ADDENDUM #1

March 23, 2018

**UNC Charlotte Sycamore Hall Renovation
Charlotte, North Carolina
SCO #16-12735**

BULLETIN DRAWING TITLE:	PROJECT NUMBER SCO ID#16-12735
_____	DRAWING NUMBER SBD-01
_____	RE: S801
_____	_____

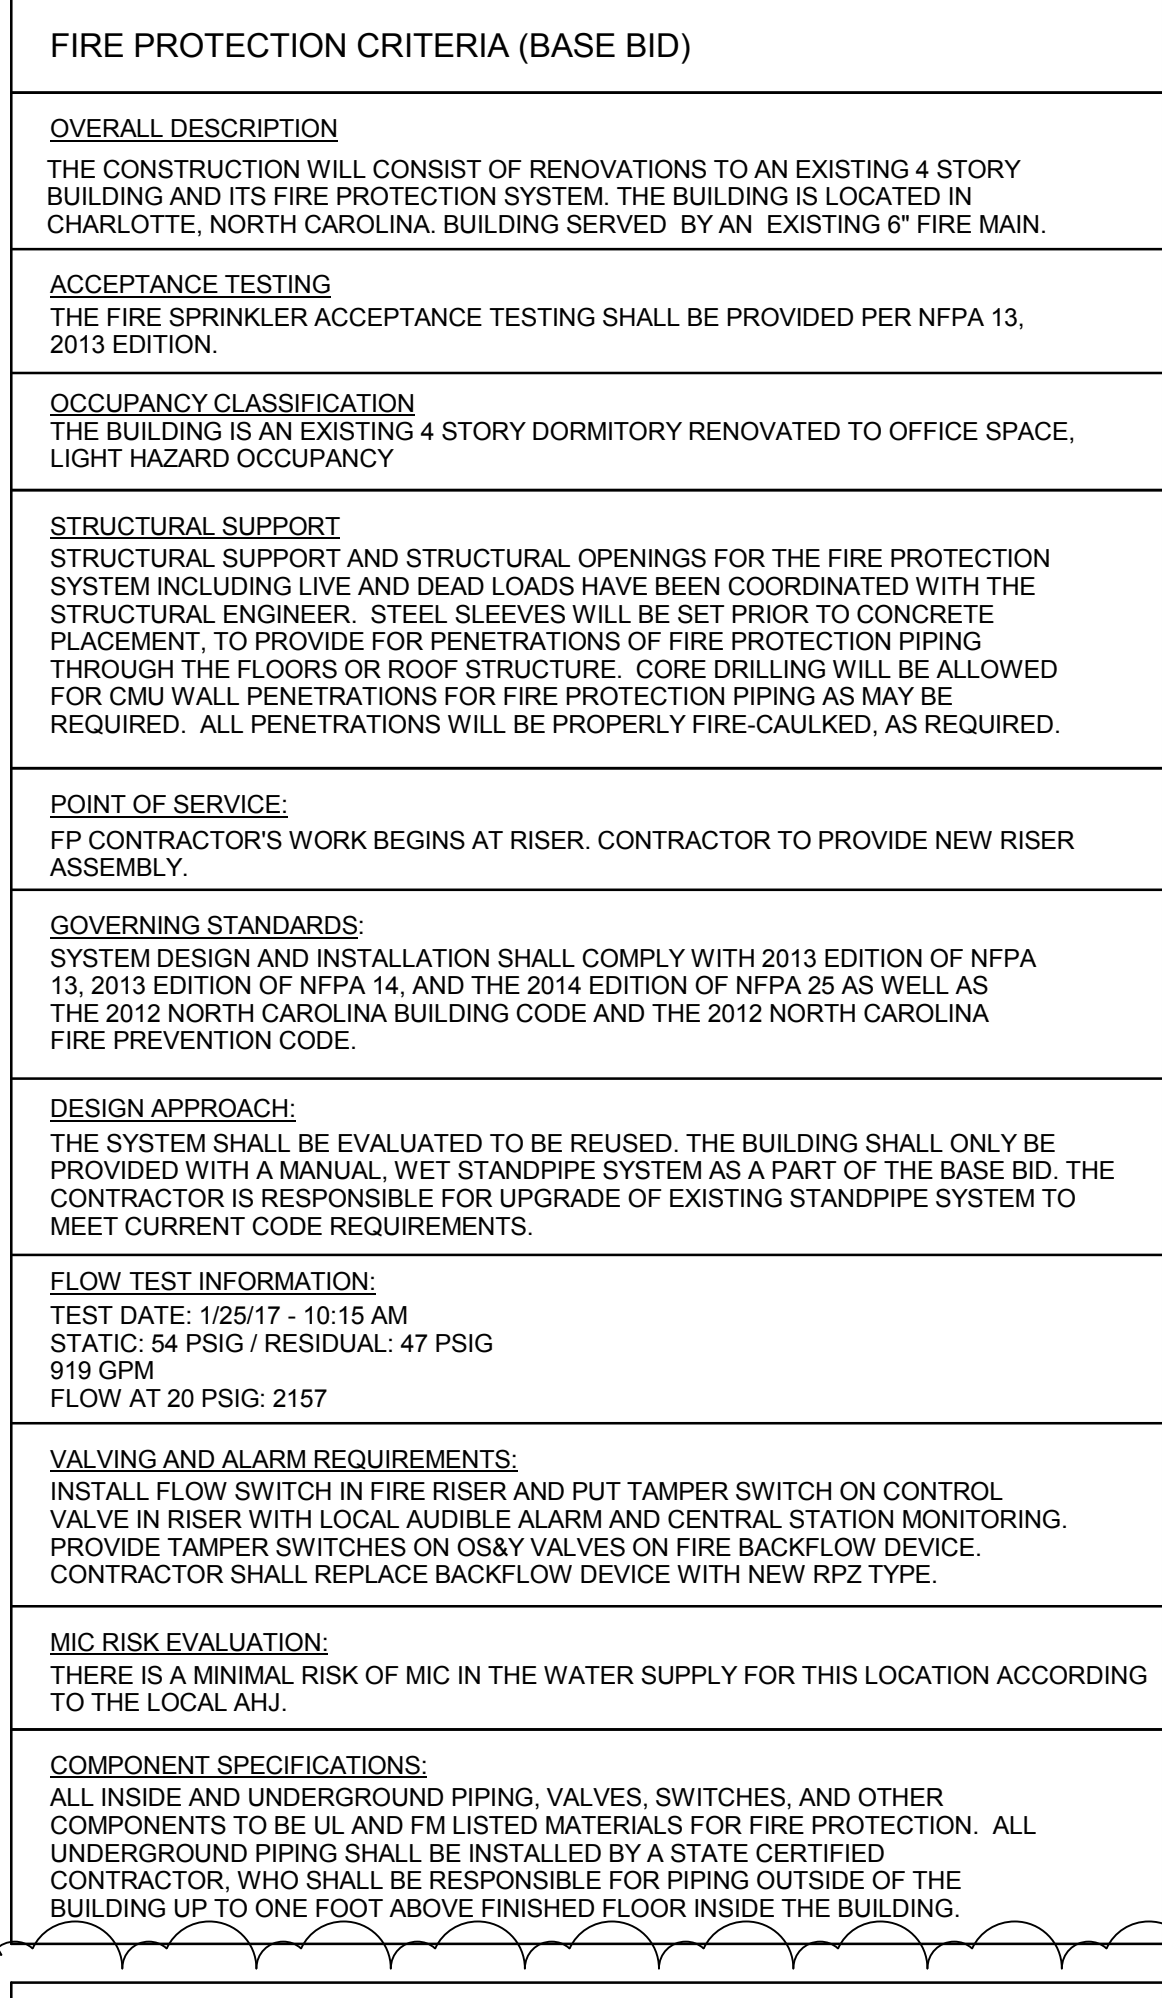
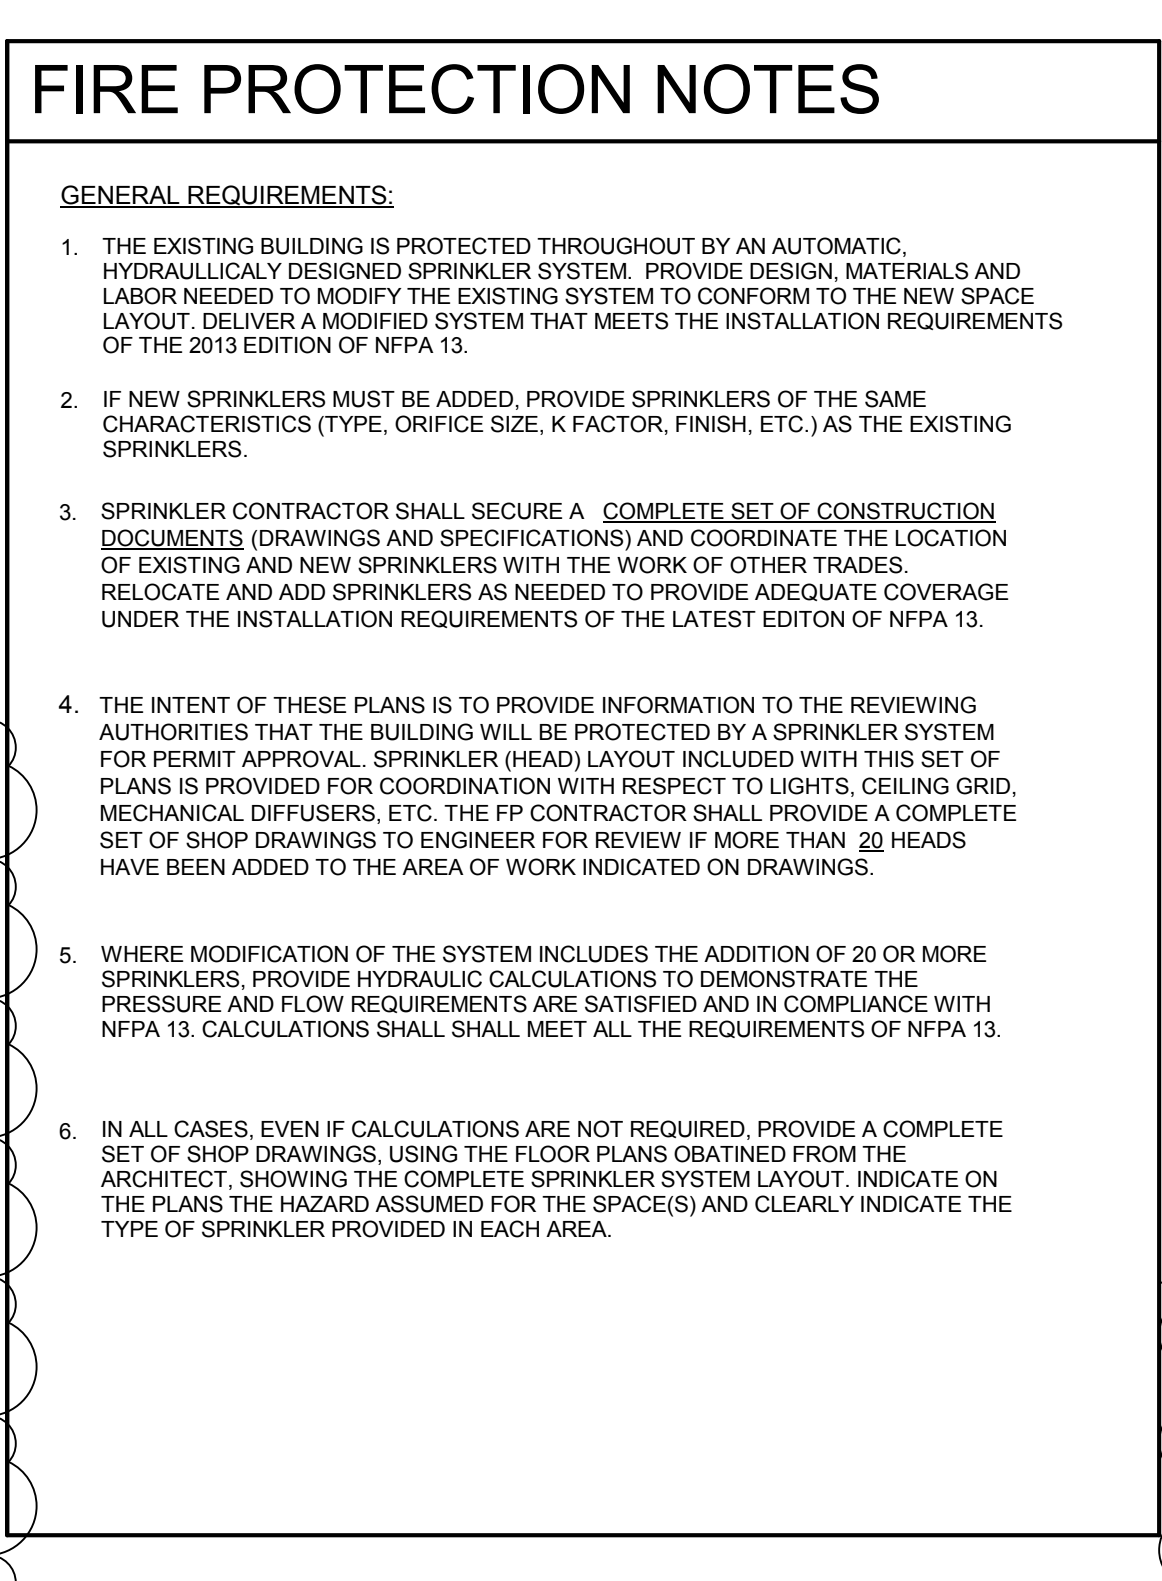
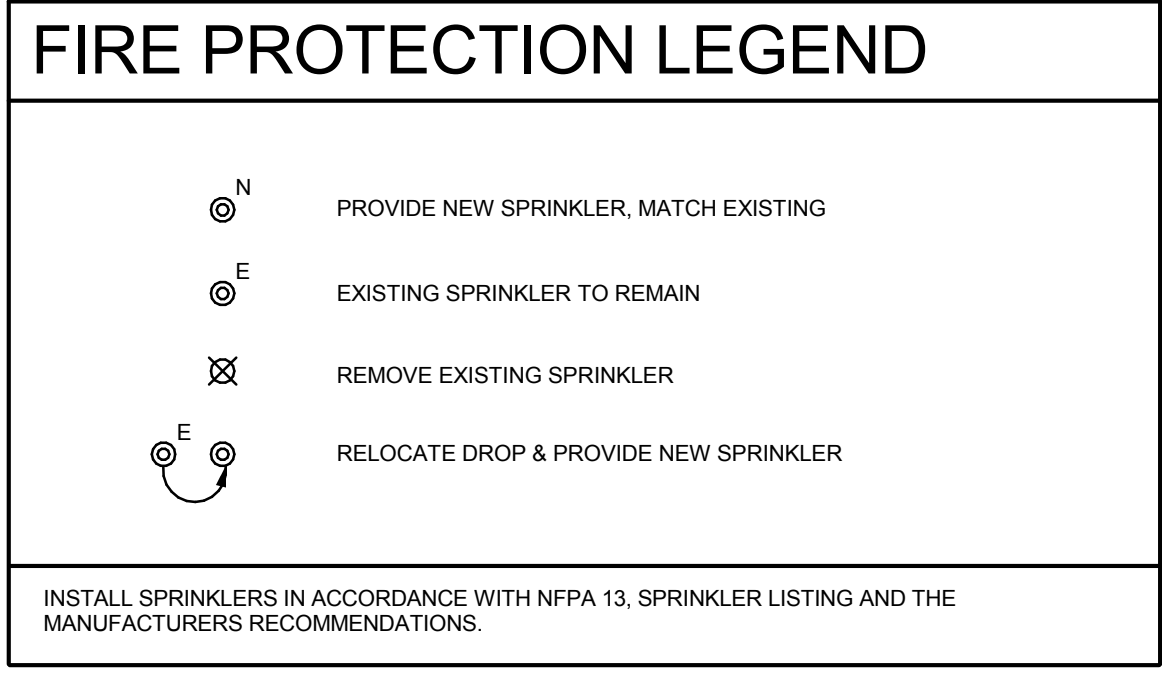
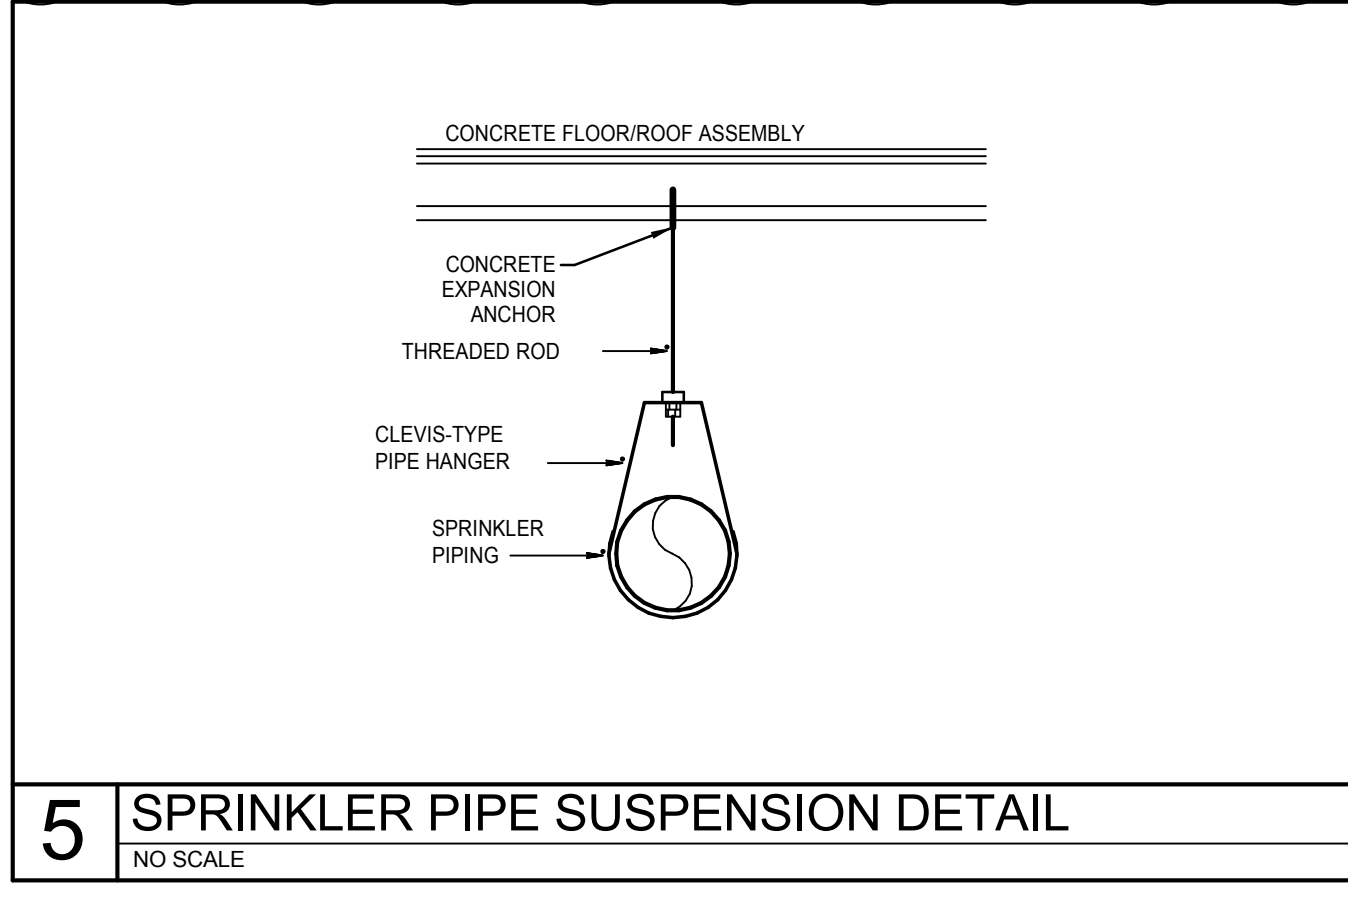
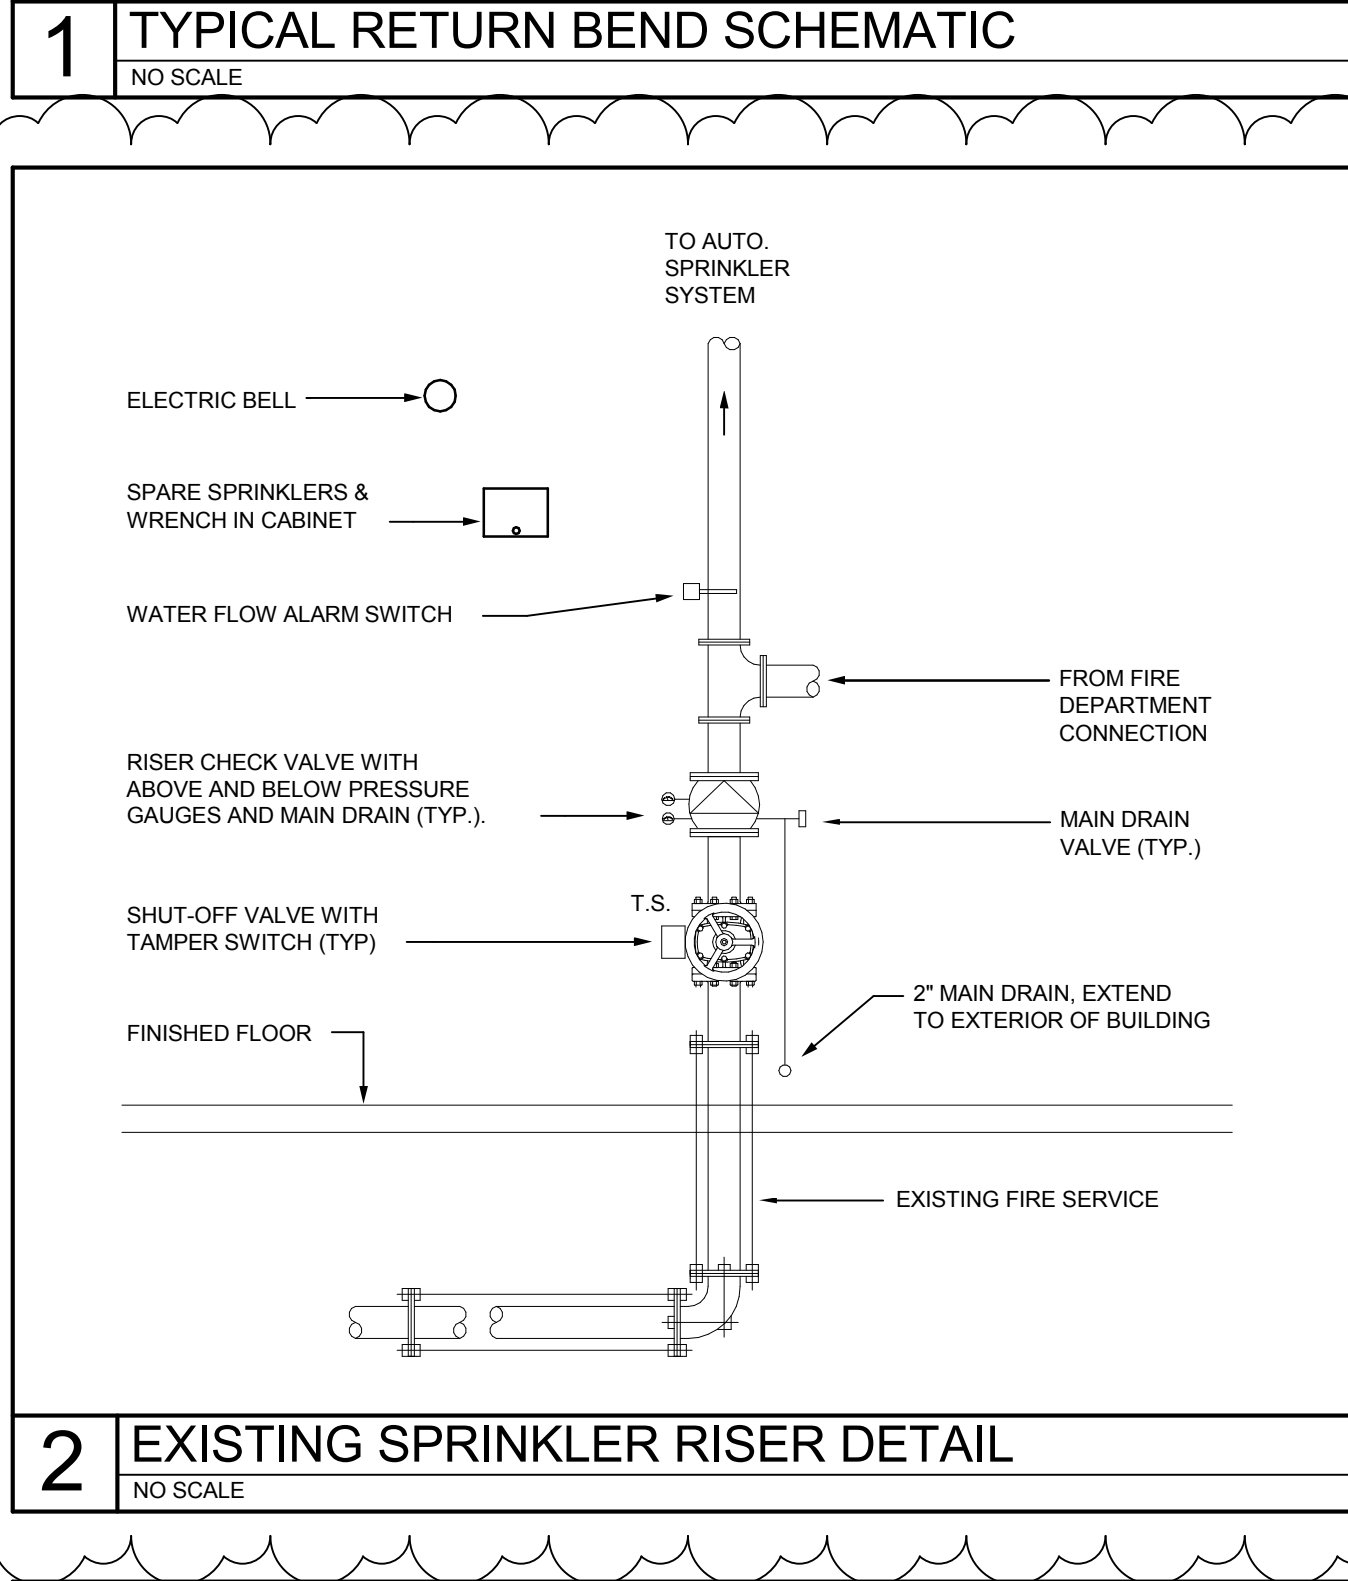
1. SBD-001, Addendum #1 revisions to detail 9/S801.
2. Replace Sheet FP001 with attached Sheet FP101.
3. Replace Sheet E006 with attached Sheet E006.
4. Replace Sheet AF100 with attached Sheet AF100.

PURPOSE OF DRAWING: ADDENDUM #1 REVISIONS
